Noise Action Plan for Brisbane – Package 3

NAPfB Package 3 - Initial ATC Feedback

Summary of NAPfB Package 3 Design Concept feedback provided by Airservices Ops and External Industry stakeholders

Noise Action Plan for Brisbane (NAPfB) - Package Three Preferred Options Internal Executive Steering Group (IESG)

D.01 – R19R WACKO BIXAD SIDs

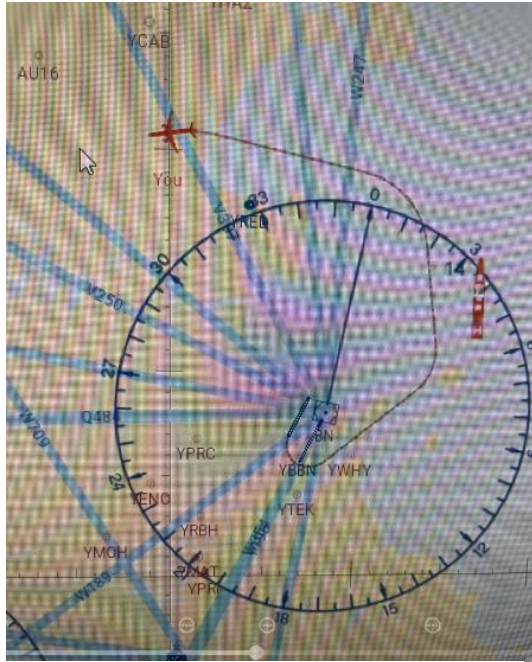
- Highlighted importance of managing speed restrictions and maintaining integrity of SID tracking, increased risk of cancellation of SID.
- Issues arise when aircraft cancel speed restrictions, leading to inability to turn quickly and deviating from SID.

- Emphasis on designing flight procedures that allow for higher speeds (e.g., 300 knots) to prevent ATC from cancelling the SID.
- Discussion of challenges with 90° turns and short legs in procedures, which are problematic for certain aircraft. Numerous aircraft can't see past the next way point in system.

- Avoiding flyover waypoints is recommended to maintain more predictable aircraft paths.
- Preference for fly by instead of fly over points for gentler turns.

- Consideration of noise abatement and the trade-offs between flyover and fly-by methods.
- Potential benefits of diverging runway tracks by 10° to improve operational efficiency and independence

- Interest in speed restrictions and height requirements on proposed new SID.
- Request for GPS coordinates for waypoints and associated restrictions.

- Concerns about new path over high-density housing in city.
- Consideration for adjustment of turbo headings?
- Importance of maintaining 5 nautical miles separation until Wacko.
 - Procedure in place for managing aircraft hand over to Enroute under 5NM exists in SEQ Mats.
- Challenges with split tracking and helicopter operations around Archerfield.
- Raising city airspace to 1000 feet for better helicopter operations.
 - Making city airspace a Class G Controlling Authority by Brisbane Approach.
 - What considerations for emergency helicopters (city hospitals) and city scenic flight operators.
- **Sim validation needed**

2. Changes to jet departure paths over land to the south and southeast (Legacy Runway)

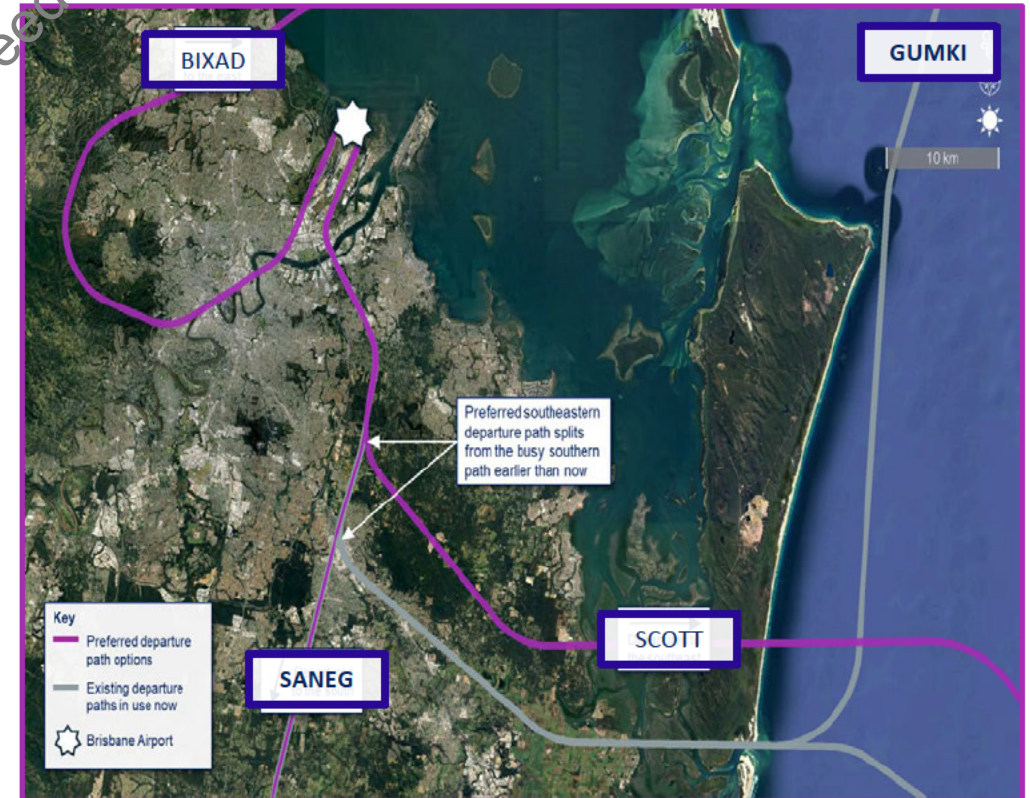
- Shifting SANEG further west (as previously engaged on) would reduce noise concentration in areas closer to the airport (Tingalpa, Wakerley, Gumdale) but increased noise in suburbs already affected by the Legacy Runway RNP-AR (Cannon Hill, Carina, Carindale).
- Earlier separation of SCOTT and SANEG paths would further reduce concentration of noise impacts in areas south of the airport, but is not operationally feasible due to non-jet departure paths.

2.2 Changes to jet departure paths over land to the south-east and east (Legacy Runway)

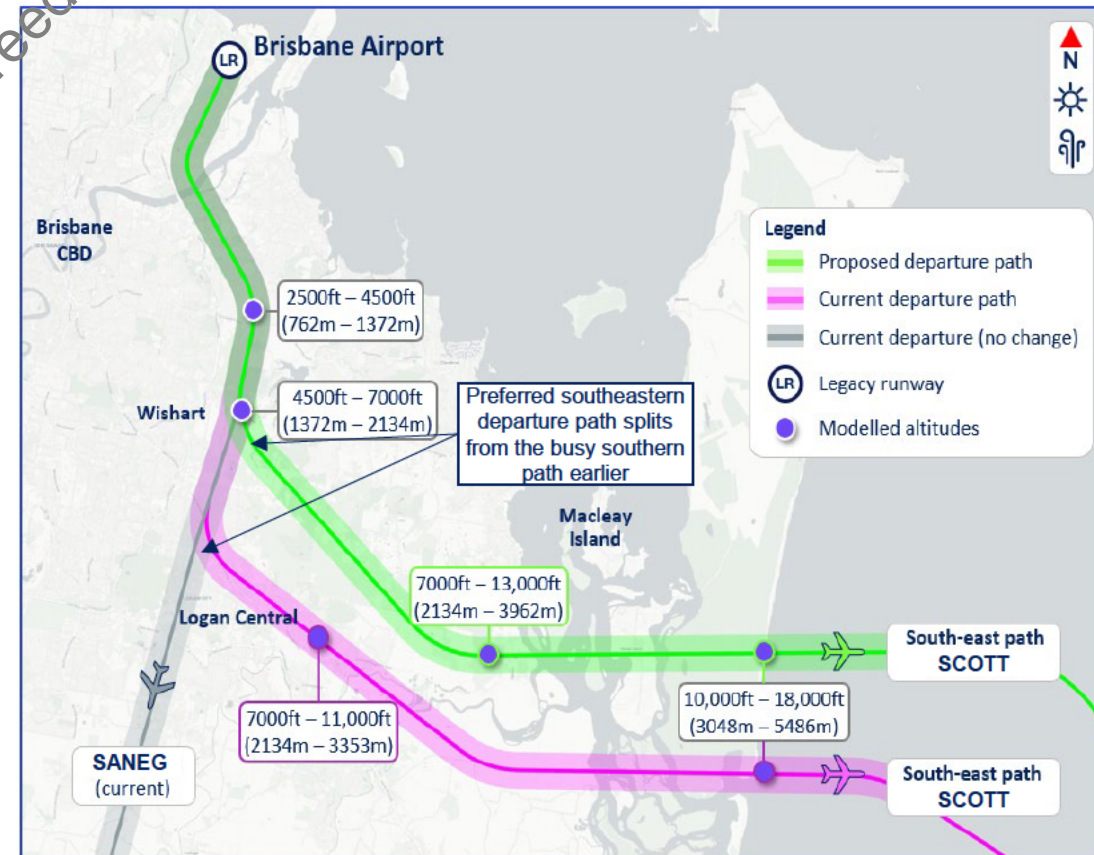
- Shifting SANEG further west (as previously engaged on) would reduce noise concentration in areas closer to the airport (Tingalpa, Wakerley, Gumdale) but increase noise in suburbs already affected by the Legacy Runway RNP-AR (Cannon Hill, Carina, Carindale).
- GUMKI to be moved to 19R or realigned with proposed SCOTT SID
